Docket Item # 13
BAR CASE # 2009-0122

ISSUE: Alterations
APPLICANT: Fred L Brewer
LOCATION: 416 North Union Street
ZONE: RM

The applicant is requesting approval of a Certificate of Appropriateness for the installation of a roof access deck at 416 North Union Street. The applicant has indicated the installation of a roof access hatch for the purpose of egress to the roof deck; however it will not be visible. The only portion of the proposed alterations visible from the public-right-of-way will be the railing around the perimeter of the roof deck. The applicant has selected a Fairway composite railing system with square balusters that will measure three feet in height. On the flat portion of the roof where the proposed roof deck is located, the existing membrane roofing material will be removed and replaced with Duradek vinyl pedestrian traffic membrane which is a combination roofing and outdoor flooring material. The installation of the roof deck will require the relocation of two AC units from their existing location on the roof to within the boundaries of the new railing. The Board granted a waiver of HVAC screening for the existing units in 2002 (BAR2002-0295) due to their mini

Figure 6. Proposed roof plan.

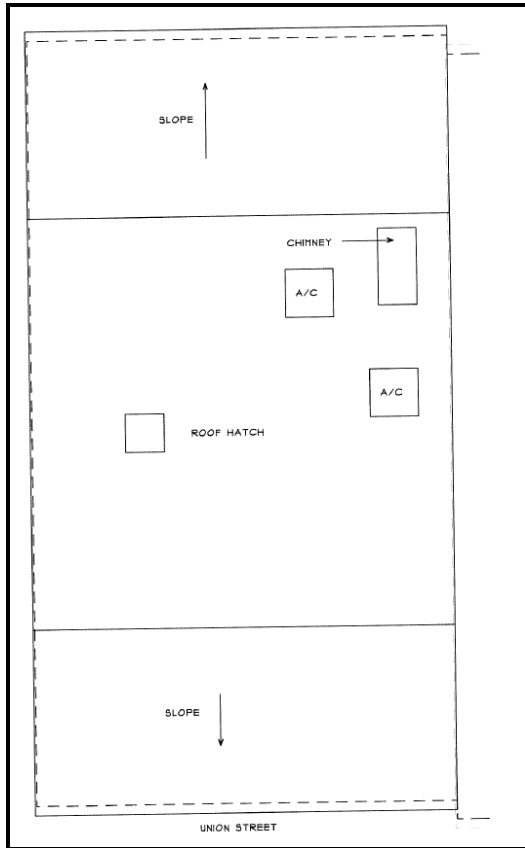
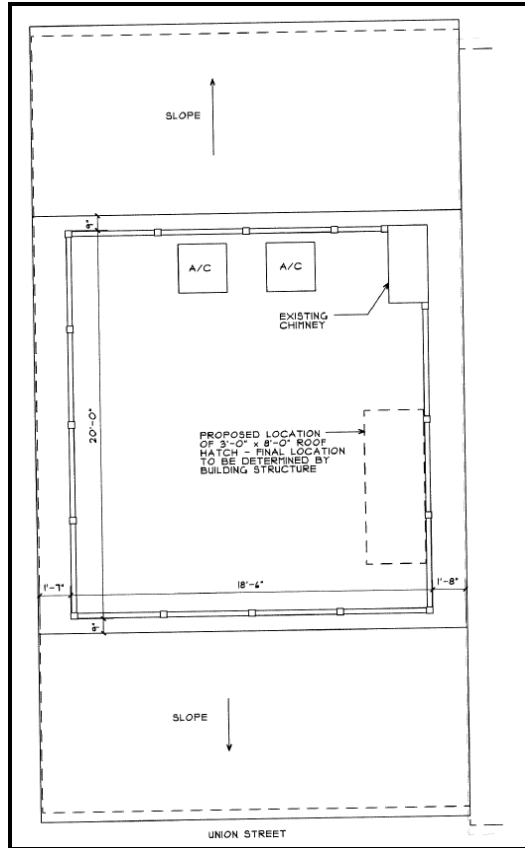
- C-1 Where appliances are located $\leq 10'$ from a roof edge or open side with a drop $\geq 24"$, guards shall be provided (USBC 2801.1)
- C-2 Structural calculations are required to verify the ability of the existing roof to support the additional weight of the A/C unit.
- C-3 Guardrail structural design and construction must comply with USBC.
- C-4 Construction permits are required for this project. Plans shall accompany the permit application that fully details the construction as well as layouts and schematics of the mechanical, electrical, and plumbing systems.
